INITIAL FIRE SAFETY INSPECTION REPORT

Adury Fashion & Print Ltd.

RSC ID: 26472

Date: 28-Oct-2025

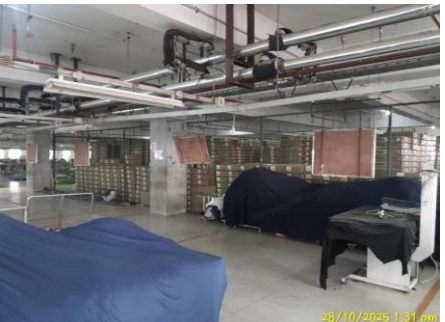
F-13	Means of Egress	The guards have gaps that are too large, allowing a sphere 200 mm (8 in.) in diameter to pass through. Location: All Handrail of Building-13.	Open guards shall have intermediate rails or pattern such that a sphere 200 mm (8 in.) in diameter cannot pass through any opening up to a height of 865 mm (34 in.).	Within 3 Months

F-14	Means of Egress	Some lighted exit signs were two-sided, so that they indicated an exit where there were none. Location(s): 1st floor, Building-13.	Ensure that lighted exit signs are only visible from the side that directs people toward an exit path.	Within 1 Month
